**STREAMLINED REMEDIATION SYSTEM EVALUATION (RSE-LITE)  
FOR A GROUND WATER PUMP AND TREAT SYSTEM**

**CHEMKO TECHNICAL SERVICES, INC. FACILITY  
MIMS, FLORIDA**

AUGUST 8, 2005

EPA 542-R-05-018  
August 2005  
[www.epa.gov/tio](http://www.epa.gov/tio)  
[clu-in.org/optimization](http://clu-in.org/optimization)

**Figure 1. Contaminant Concentration Map - Shallow Zone (8 to 13 feet NGVD)**

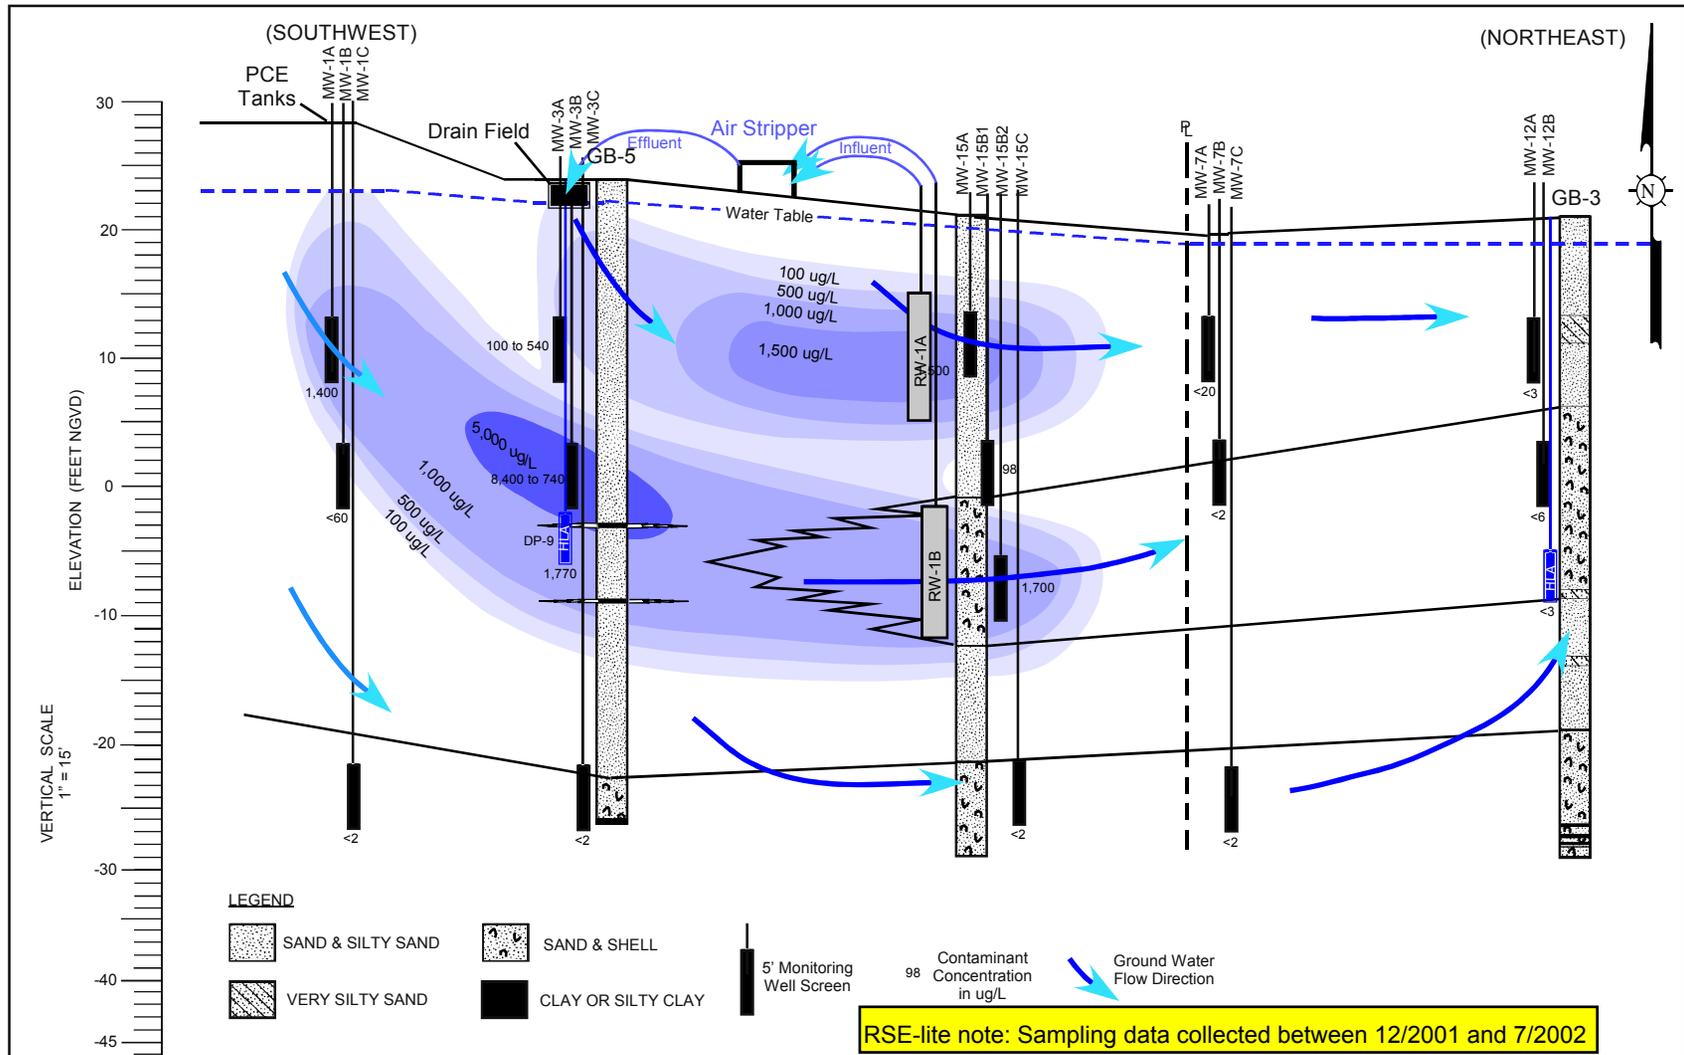
Two of the residences noted in Figure 1 (attached at the end of this document) are located within the estimated extent of the downgradient contaminant plume. Given that relatively shallow ground water is contaminated, the site team should consider the potential for vapor intrusion at these two residences. The site team may begin by determining if the residences have basements or sumps that may increase the likelihood of vapor intrusion. In addition, the site team should consider the depth to ground water and the level of contamination. If these initial considerations suggest the possibility of vapor intrusion, the site team should likely consider taking indoor

vapor samples from these residences. Additional vapor samples may also be appropriate if the contaminant concentrations in shallow ground water near the residences increase as the plume continues to migrate. Based on site figures, MW-7A, MW-12A, and MW-14A appear to be the most appropriate wells to monitor with regard to vapor intrusion at these residences. Based on the reported site costs, a preliminary evaluation of the two residences and vapor samples from each residence might cost \$2,000 for a single event, including the analytical costs.
